HOWARD COUNTY HISTORIC PRESERVATION COMMISSION
ELLCOTT CITY HISTORIC DISTRICT ■ LAWYERS HILL HISTORIC DISTRICT
3430 Court House Drive ■ Ellicott City, Maryland 21043

September Minutes

Thursday, September 3, 2020; 7:00 p.m.

Figure 14 - Damage to existing wall.

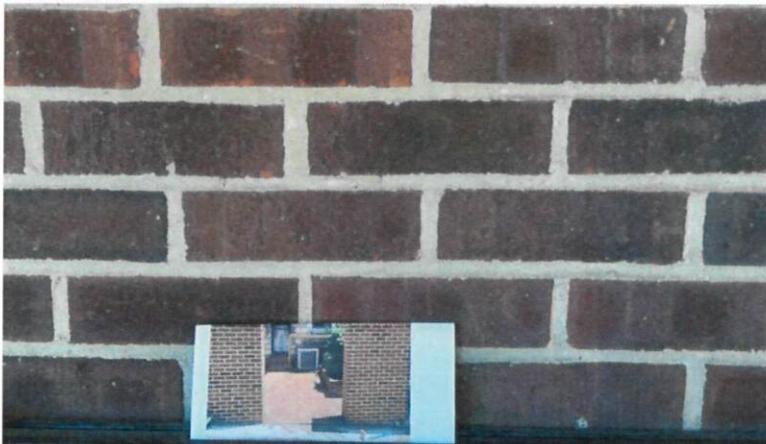
The application states the wall will match the existing, so as long as the design and dimension of the wall, and the shape and color of the brick exactly match the existing, shifting the wall two feet will not affect the integrity of the building. The alteration is a minimal change and complies with the Guideline recommendations to use materials matching the existing.

Mr. Shad swore in Jane Johnson and asked if Ms. Johnson had any comments on the Staff report. Ms. Johnson said there was a question in the Staff report as to why real brick was not being used on the wall. Ms. Johnson said per her contractors the preferred method was to use the concrete material to hold back any water pressure on the ground. All the contractors Ms. Johnson spoke to recommended concrete faced with brick to avoid the wall failing again in a flood.

Ms. Tennor had a question about descending height of the wall. She said the wall goes down in three descending heights and at each change in elevation, the current wall has a transition detail of a rotated brick from a higher level to a lower level and the middle part of the wall does not have the transition detail. Ms. Tennor asked if the Applicant intended to recreate that transition detail, as the wall changes height. Ms. Johnson said she will request to see if the transition can be done from the contractors. Ms. Tennor added the detail she described occurs at the end of the wall by the sidewalk and the detailing should be consistent from one level to the next and have planned transitions like the original wall. Ms. Tennor recommended each transition be consistent in the new wall.

Ms. Tennor pointed out the awning over the existing wall has footers holding the awning up over the alcove area and said the application did not address how the awning will be supported on the new wall. Ms. Johnson said she would like to replace the awning eventually but was not able to do it at this time. The current support system is bent so the intent is to have the footers repaired so that Ms. Johnson can replace the awning and the supports will be straight and fixed and tied into the wall like it is currently.

Ms. Zoren agreed with Mr. Reich and thought the brick veneer was a true brick. She suggested the Applicant verify that the brick veneer will be a true depth brick and not a thin brick. Ms. Zoren said the concrete wall should be faced with the brick veneer and no concrete exposure should be seen. Ms. Zoren asked if there would be a brick cap, capstone or slab on top of the wall and said if the wall did not look like the existing wall, that the Applicant would need to come back for a different cap on the retaining wall. Ms. Zoren asked if the concrete slabs by the retaining wall will be repoured or patched. Ms. Johnson said the expanded area under the awning, between the wall of the building and the retaining wall will be repoured with concrete.

Figure 18 - Site conditions in January 2020. North of house looking east toward railroad tracks.

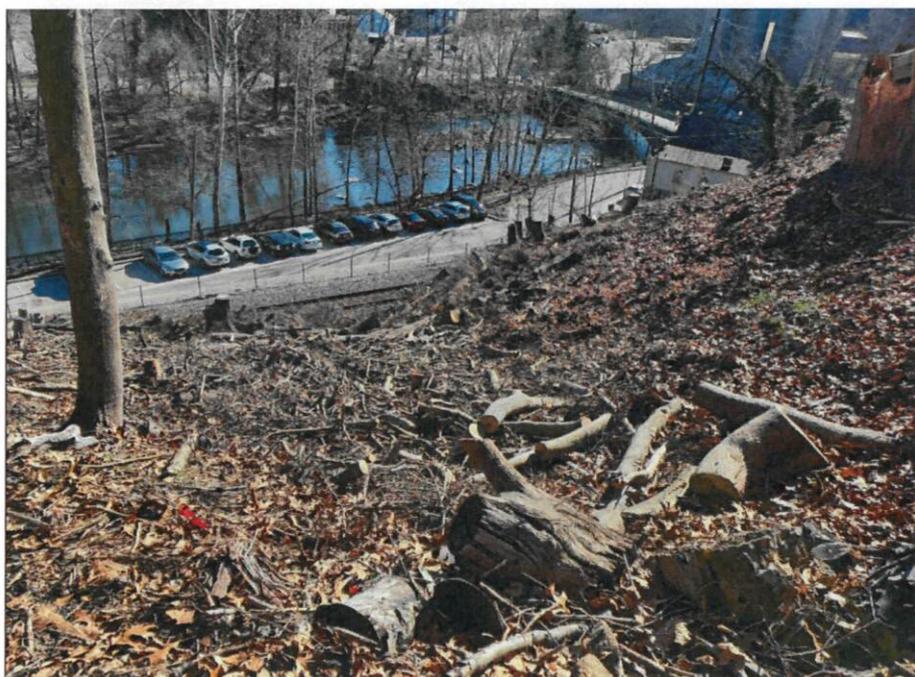
Mr. Petty asked how many canopy trees would be required to be planted on the property. Ms. Tennor said there were twelve trees that were removed with a diameter of 12 inches or greater. Ms. Tennor said there should be a good faith effort to replace a good number of the twelve trees, if not all twelve. She said the removal of the twelve trees was excessive.

Mr. Roth and Mr. Taylor discussed the Commission's role with reviewing replacement trees in a historic setting. Mr. Roth said the proposed plantings seem to be appropriate within the Guidelines as they are native trees and would complement the historic setting and based on locations of where the previous trees where as shown on sheet C-1 of the application tree removal schedule labeled T1-T12, the trees were very close to the house or on a steep slope in close proximity to the railroad tracks it may have been appropriate to remove them.

Ms. Zoren said the wood timber walls were not appropriate. She said for this property, the house was very grand and had a lot of masonry and heavy materials which did not seem compatible with the timber walls. Ms. Zoren suggested the Applicants return with a landscape plan that had the final vision for the property, even if the work would be completed in phases.

Figure 21 - Cathedral window to be restored

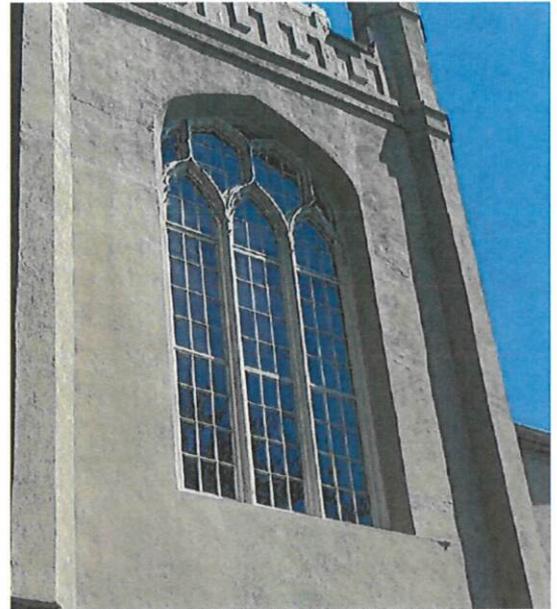
Ms. Tennor appreciated the summary of the process as it was very detailed and sequential. Ms. Tennor asked, in regard to Item F for repairing any broken parts of the window, if Mr. Mason's contractors had expressed intent to replace broken parts of the window with in-kind materials and minimize the amount of the window that had to be replaced. Mr. Mason said the intent of the project was to minimize replacement. Mr. Mason was not sure if the window had ever been replaced. He was not sure what the hardware materials were that make up the window due to the numerous coats of paint causing the window to be painted shut. He said there were a few areas where the wood was dry rotted and could be pushed through. Mr. Mason hoped to make the window operable again and get the window back to original condition.

Ms. Tennor noted there are 6-divided light windows with three windows across. Ms. Tennor asked if the divided light windows would be removed from the shop and repaired and if the ornate shaped windows above the divided light windows would be repaired on site. Mr. Mason confirmed Ms. Tennor's question to be correct.
